ANALYSIS OF FIRE DETECTOR LOCATIONS
AT
LASALLE COUNTY STATION
FOR
SARGENT & LUNDY ENGINEERS
AND
COMMONWEALTH EDISON COMPANY

May 14, 1984

SEC Project No. 83118

UNIT-1
DIESEL GENERATOR ROOM
PLAN EL.710'-6"
FIRE ZONE 7B1-3

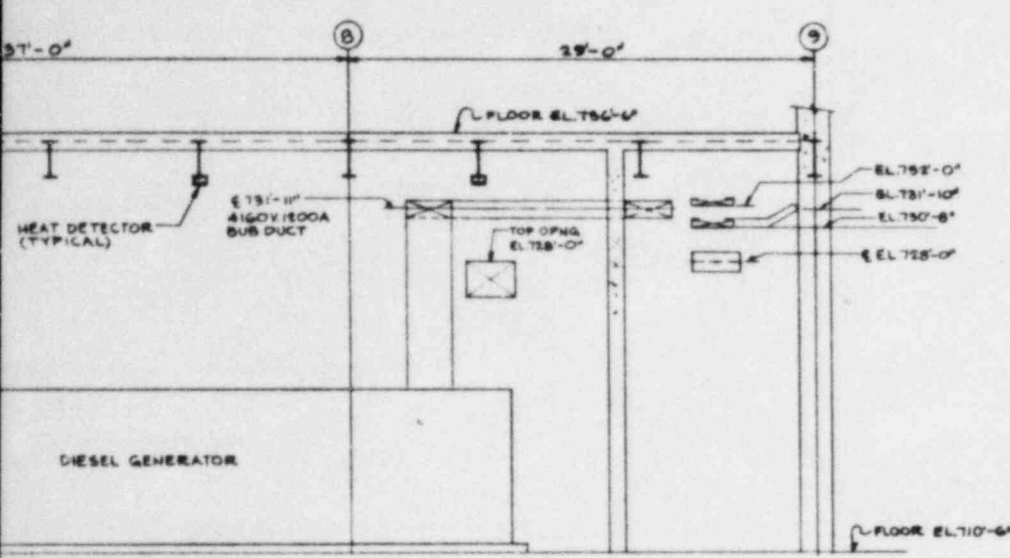
The sensitivity of a detector will be lessened in a high ceiling area. NFPA 72E has recognized this and recommends a listed spacing of 46 percent when ceiling heights are between 24 and 26 feet. With this reduction, the installed detector spacing exceeds the adjusted listed spacing. Also, detectors have been located over the generator. The generator occupies one-half of the room and, as such, detectors are spaced too far from the opposite wall.

The room is subdivided by a deep beam running north and south. Five additional 27-inch deep beams further subdivide the ceiling of the zone into bays. According to NFPA 72E, detectors would normally be required in each bay, thereby requiring an additional 12 detectors. However, because of the height of the ceiling (see above discussion) and the possibility of heat rising and filling the bays when the generator is running (e.g., a normal operation or maintenance run), it is recommended that detectors be located at the bottom of alternate W27 beams on the east side of the north/south beam. In this way, the beam flange will serve as the heat collector while mounting detectors some distance below the ceiling will lessen the possibility of a false trip. On the west side of the north/south beam, the ceiling height is lower. Due to the reduced ceiling height, two detectors should be installed in this area.

The sensitivity of a detector will be lessened in a high ceiling area. NFPA 72E has recognized this and recommends a listed spacing of 46 percent when ceiling heights are between 24 and 26 feet. With this reduction, the installed detector spacing exceeds the adjusted listed spacing. Also, detectors have been located over the generator. The generator occupies one-half of the room and, as such, detectors are spaced too far from the opposite wall.

The room is subdivided by a deep beam running north and south. Five additional 27-inch deep beams further subdivide the ceiling of the zone into bays. According to NFPA 72E, detectors would normally be required in each bay, thereby requiring an additional 12 detectors. However, because of the height of the ceiling (see above discussion) and the possibility of heat rising and filling the bays when the generator is running (e.g., a normal operation or maintenance run), it is recommended that detectors, for the most part, be located at the bottom of alternate deep beams on each side of the north/south beam. In this way, the beam flange will serve as the heat collector while mounting detectors some distance below the ceiling will lessen the possibility of a false trip.

The sensitivity of a detector will be lessened in a high ceiling area. NFPA 72E has recognized this and recommends a listed spacing of 46 percent when ceiling heights are between 24 and 26 feet. With this reduction, the installed detector spacing exceeds the adjusted listed spacing. Also, detectors have been located over the generator. The generator occupies one-half of the room and, as such, detectors are spaced too far from the opposite wall.

The room is subdivided by a deep beam running north and south. Five additional 27-inch deep beams further subdivide the ceiling of the zone into bays. According to NFPA 72E, detectors would normally be required in each bay, thereby requiring an additional 12 detectors. However, because of the height of the ceiling (see above discussion) and the possibility of heat rising and filling the bays when the generator is running (e.g., a normal operation or maintenance run), it is recommended that detectors, for the most part, be located at the bottom of alternate deep beams on each side of the north/south beam. In this way, the beam flange will serve as the heat collector while mounting detectors some distance below the ceiling will lessen the possibility of a false trip.

This design would require a total of 5 detectors. The two detectors that are already installed may be relocated, thereby requiring the addition of three new 190°F ± 10°F heat detectors. These detectors should be installed as indicated on Drawing 7B1-3. All heat detectors should serve to actuate the CO₂ system. By doing this, the average area per detector will be 374 square feet, which is within the NFPA 72E guidelines for a high ceiling area.

This design would require a total of 6 detectors. The two detectors that are already installed may be relocated, thereby requiring the addition of four new 190°F ± 10°F heat detectors. These detectors should be installed as indicated on Drawing 7B1-3. All heat detectors should serve to actuate the CO₂ system. By doing this, the average area per detector will be 277 square feet, which is within the NFPA 72E guidelines for a high ceiling area.

This design would require a total of 6 detectors. The two detectors that are already installed may be relocated, thereby requiring the addition of four new 190°F ± 10°F heat detectors. These detectors should be installed as indicated on Drawing 7B1-3. All heat detectors should serve to actuate the CO₂ system. By doing this, the average area per detector will be 289 square feet, which is within the NFPA 72E guidelines for a high ceiling area.

UNIT-2
 DIESEL GENERATOR ROOM
 PLAN EL. 710'-6"
 FIRE ZONE 8B1-2

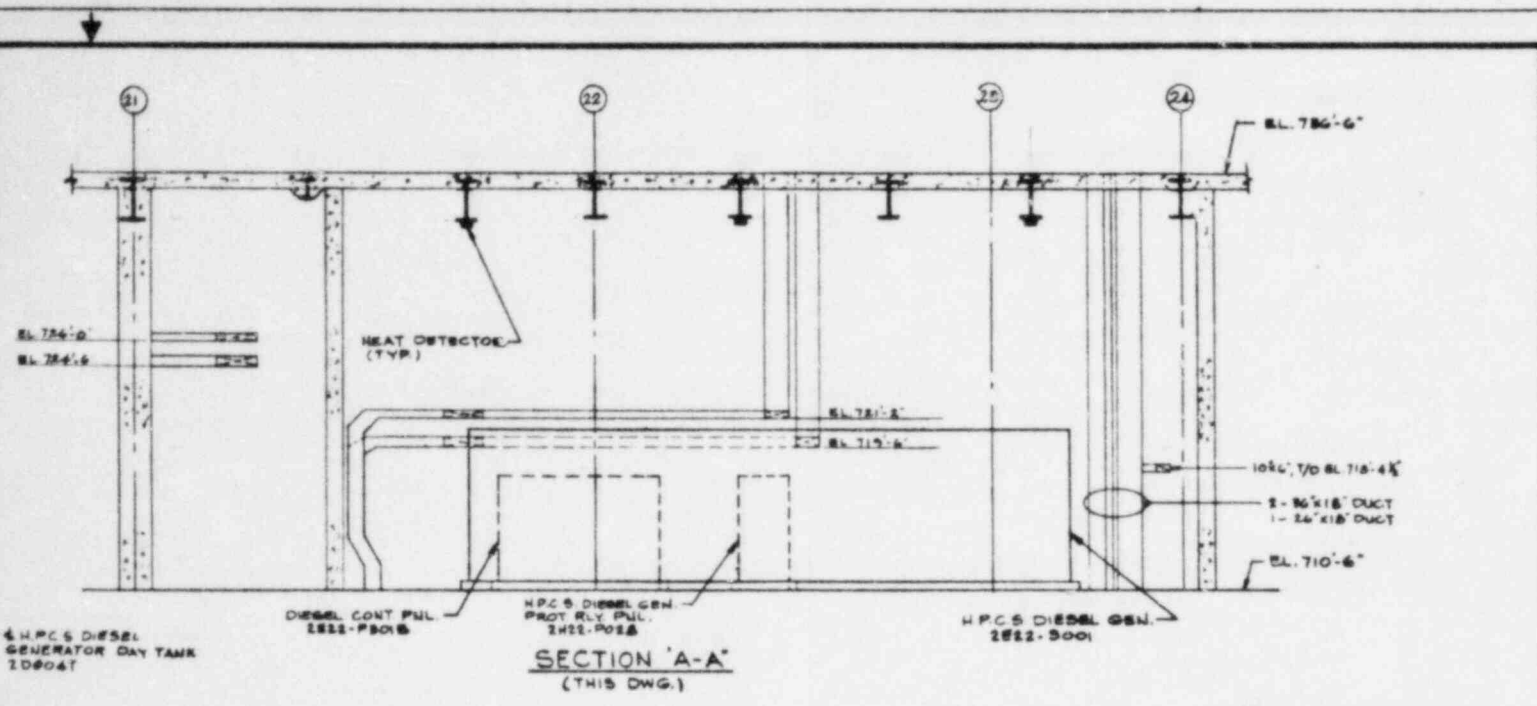
The sensitivity of a detector will be lessened in a high ceiling area. NFPA 72E has recognized this and recommends a listed spacing of 46 percent when ceiling heights are between 24 and 26 feet. With this reduction, the installed detector spacing exceeds the adjusted listed spacing. Also, detectors have been located over the generator. The generator occupies one-half of the room and, as such, detectors are spaced too far from the opposite wall.

The room is subdivided by a deep beam running north and south. Five additional 27-inch deep beams further subdivide the ceiling of the zone into bays. According to NFPA 72E, detectors would normally be required in each bay, thereby requiring an additional 12 detectors. However, because of the height of the ceiling (see above discussion) and the possibility of heat rising and filling the bays when the generator is running (e.g., a normal operation or maintenance run), it is recommended that detectors be located at the bottom of alternate W27 beams on the east side of the north/south beam. In this way, the beam flange will serve as the heat collector while mounting detectors some distance below the ceiling will lessen the possibility of a false trip. On the west side of the north/south beam, the ceiling height is lower. Due to the reduced ceiling height, two detectors should be installed in this area.

The room is subdivided by a deep beam running north and south. Five additional 27-inch deep beams further subdivide the ceiling of the zone into bays. Detectors would normally be required in each bay, thereby requiring an additional 12 detectors. However, due to the potential for activation by a heat buildup in the bays while the generator is running (e.g., a maintenance run), it is recommended that detectors, for the most part, be located at the bottom of alternate deep beams on each side of the north/south beam. In this way, the beam flange will serve as the heat collector while mounting detectors some distance below the ceiling will lessen the possibility of a false trip.

This design would require a total of 5 detectors. The two detectors that are already installed may be relocated, thereby requiring the addition of three new 190°F ± 10°F heat detectors. These detectors should be installed as indicated on Drawing 8B1-2. All heat detectors should serve to actuate the CO₂ system. By doing this, the average area per detector will be 374 square feet, which is within the NFPA 72E guidelines for a high ceiling area.

This design would require a total of 6 detectors. The two detectors that are already installed may be relocated, thereby requiring the addition of four new detectors. These detectors should be installed as indicated on Drawing 8B1-2. All heat detectors should serve to actuate the CO₂ system. By doing this, the average area per detector will be 334 square feet, which is within NFPA 72E guidelines for a high ceiling area.
